# METROPOLITAN GOVERNMENT OF NASHVILLE AND DAVIDSON COUNTY

## STAFF RECOMMENDATION 1209 A Dallas Avenue May 15, 2013

**Application:** New Construction—Addition  
**District:** Belmont-Hillsboro Neighborhood Conservation Zoning Overlay  
**Council District:** 18  
**Map and Parcel Number:** 11801006100  
**Applicant:** Kevin and Nicole G. Perkins  
**Project Lead:** Sean Alexander, sean.alexander@nashville.gov

SHEET TITLE:  
**EXISTING AND PROPOSED**

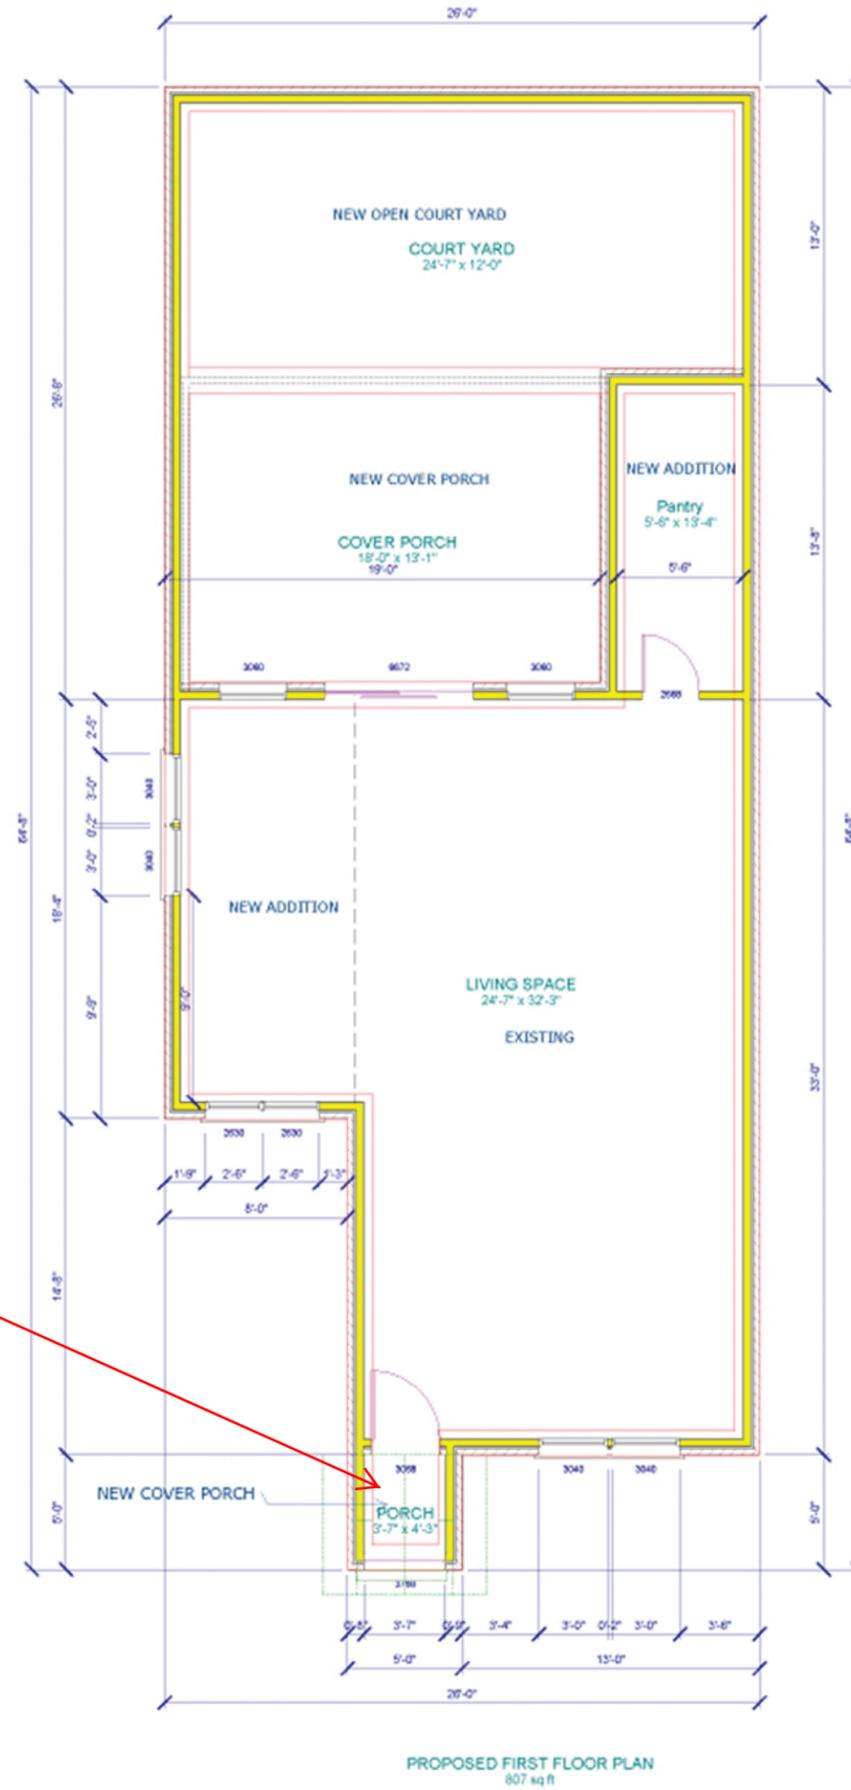
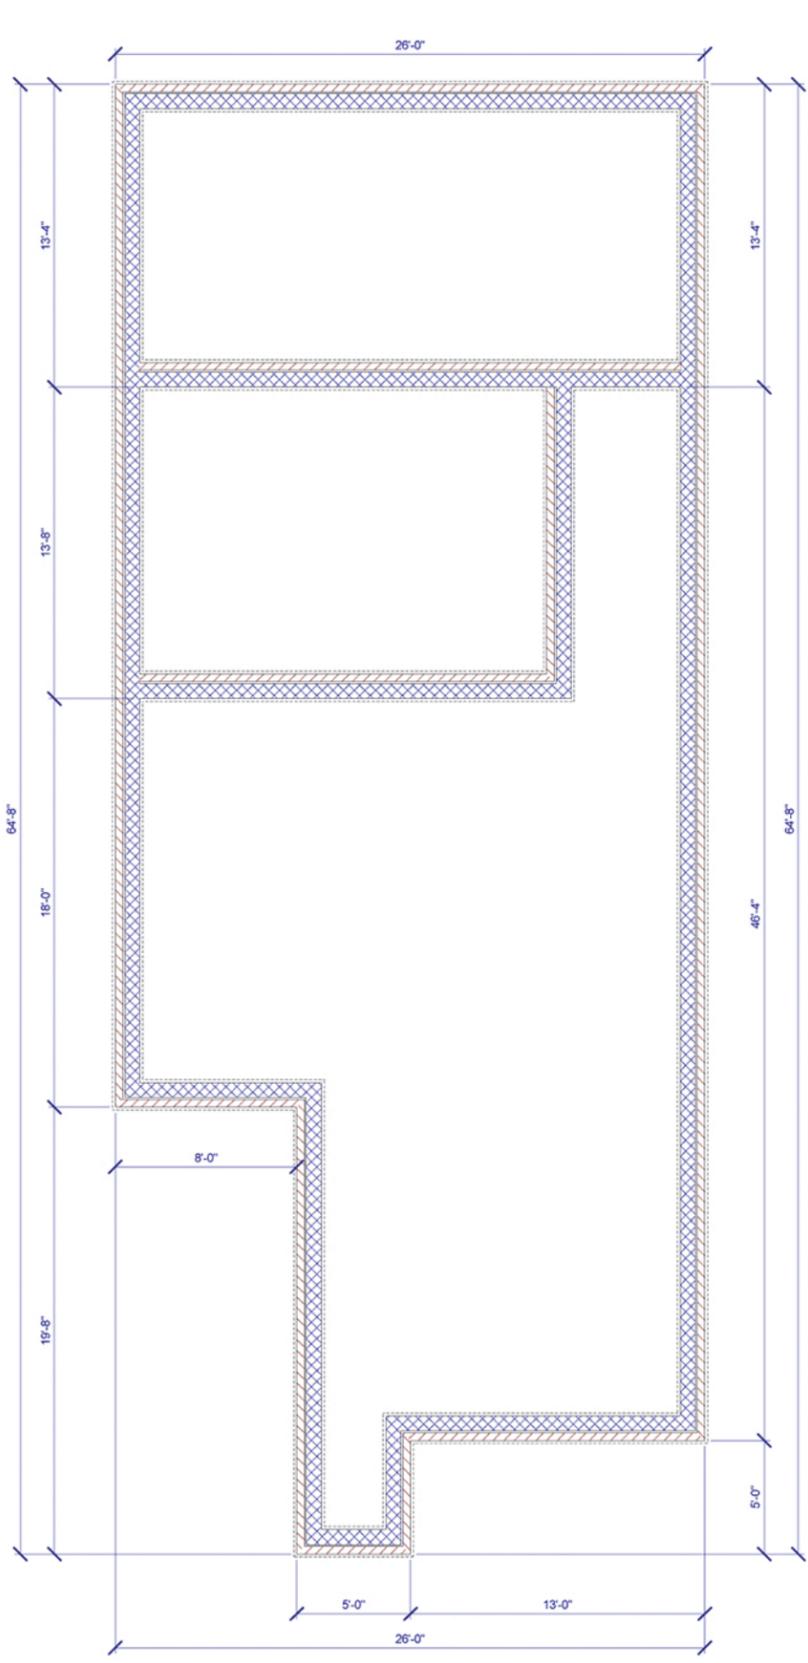
Stoop will only be 3' deep.

SHEET TITLE:  
**ELEVATIONS**

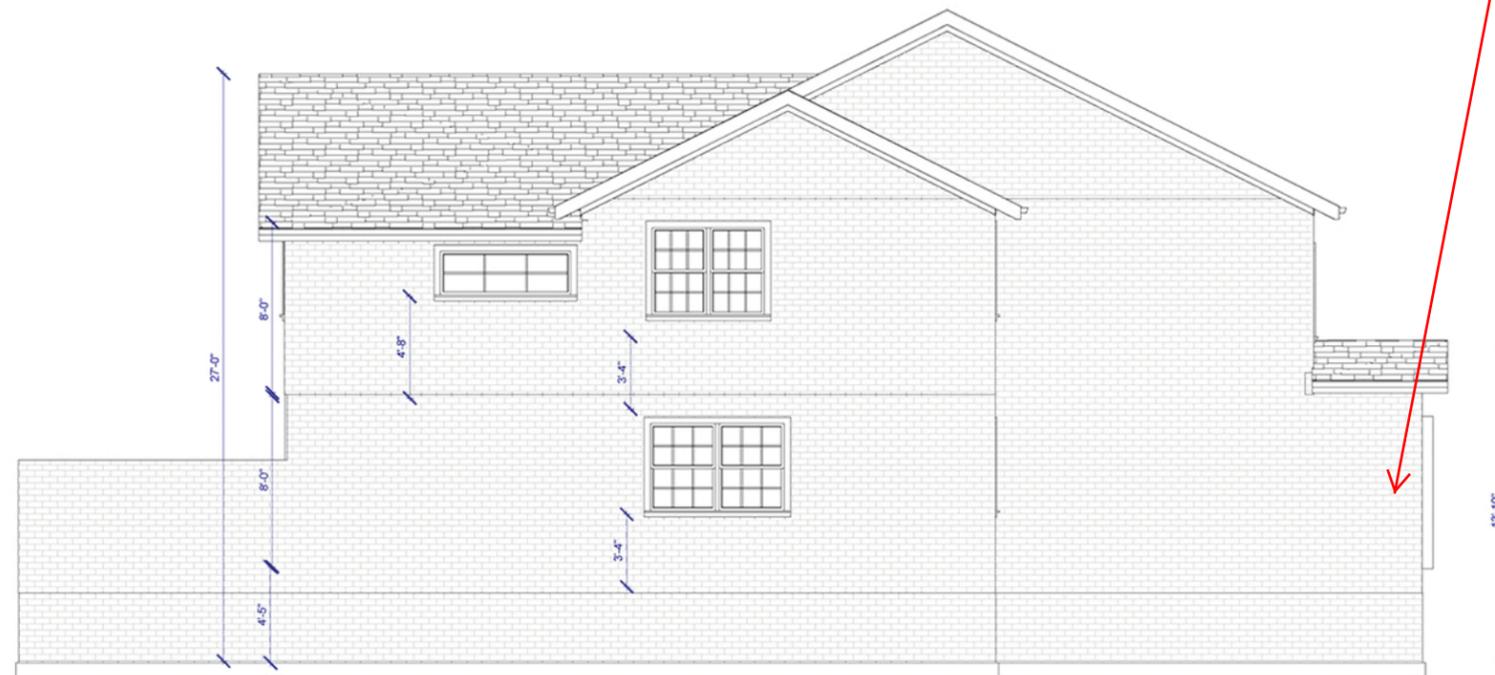
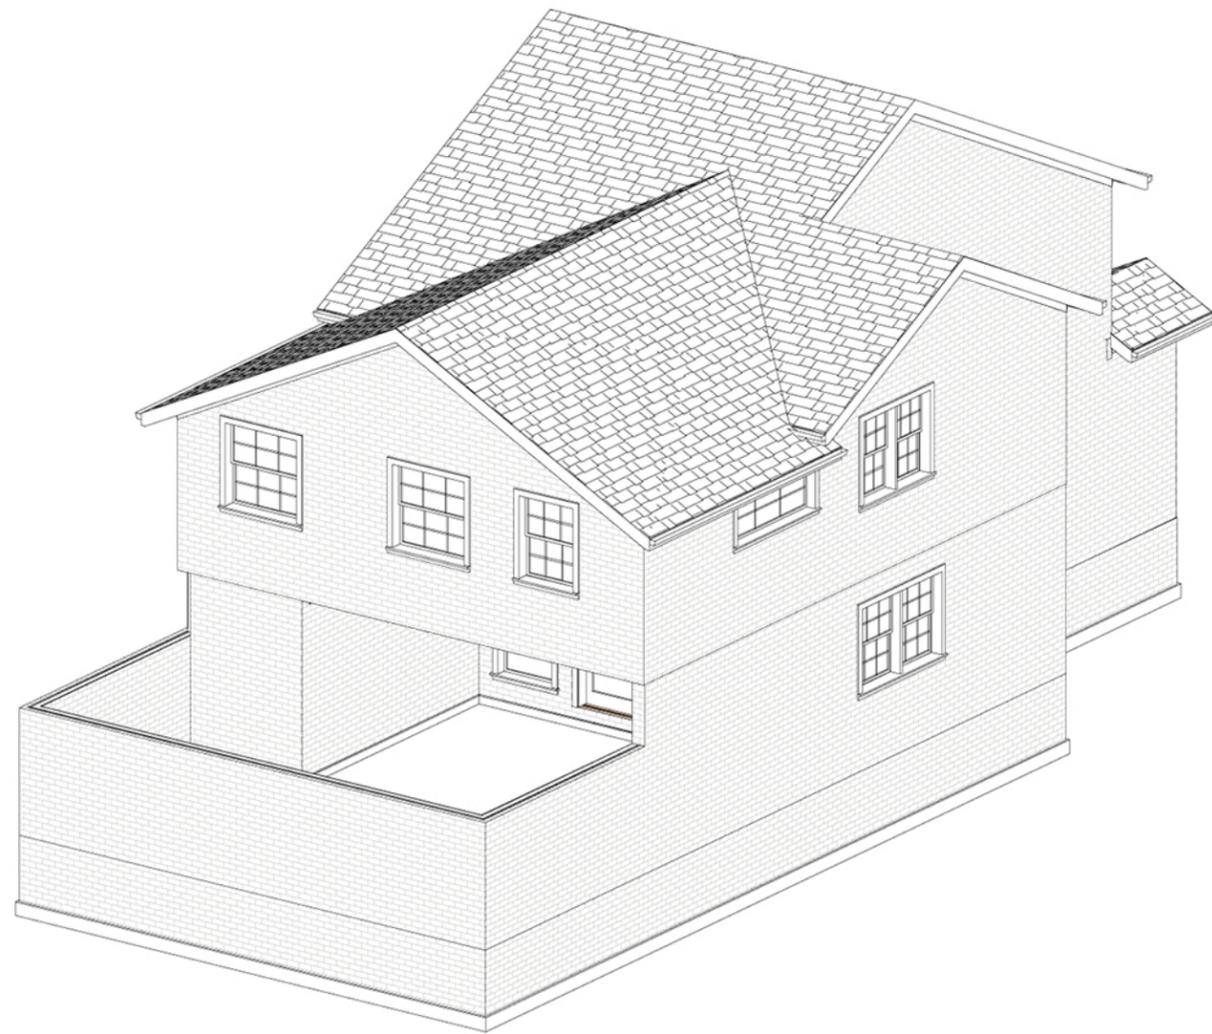
Stoop will only be 3' deep.

SHEET TITLE:  
**ISOMETRICS**

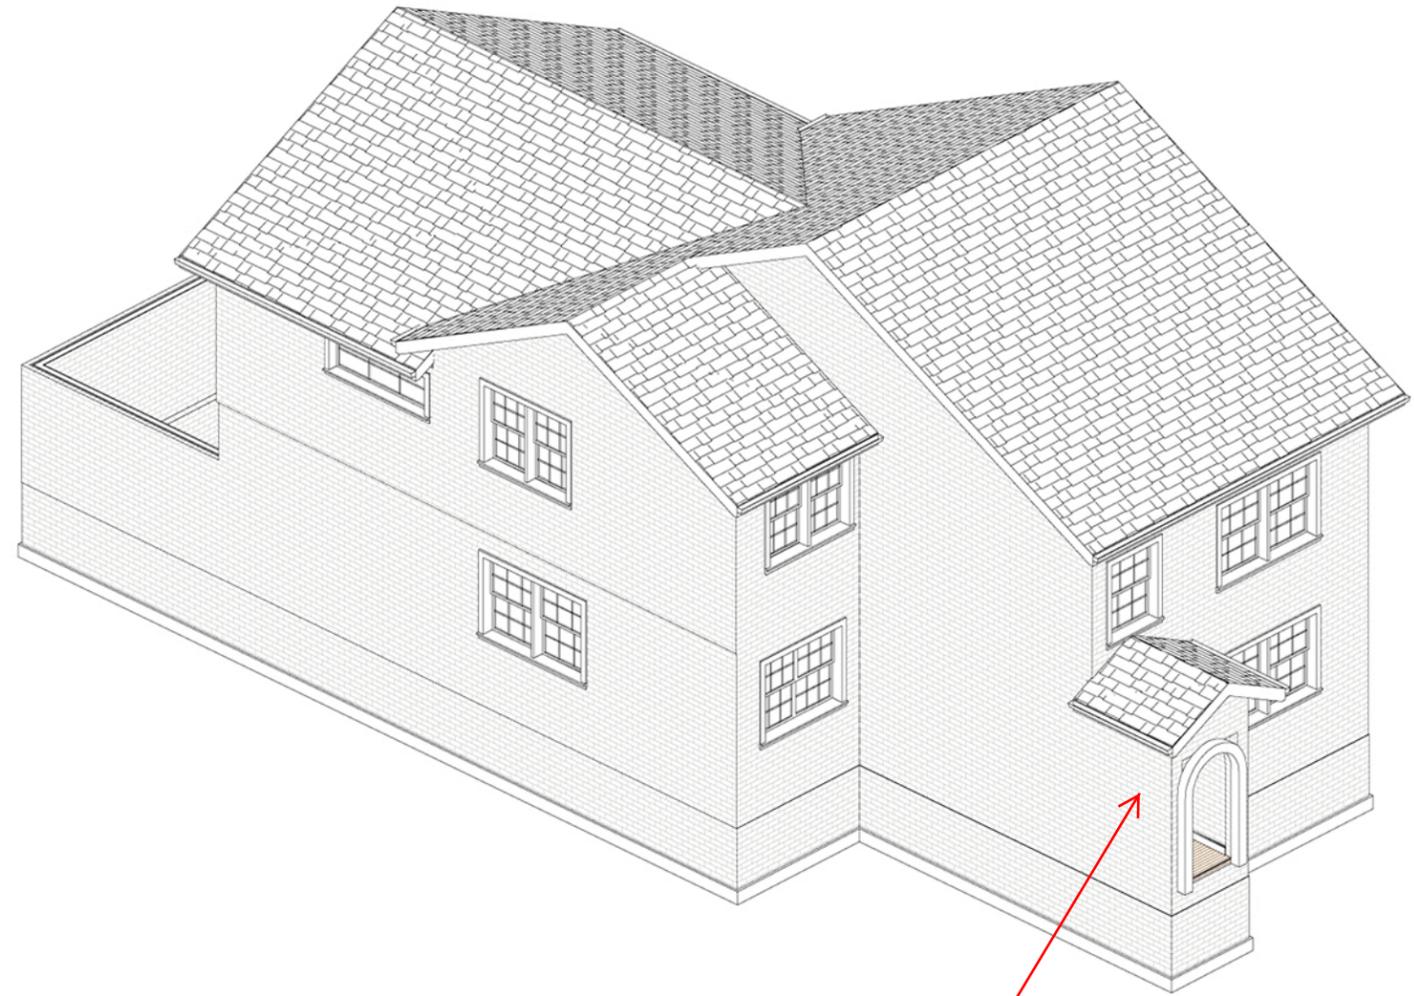
Stoop will only be 3' deep.
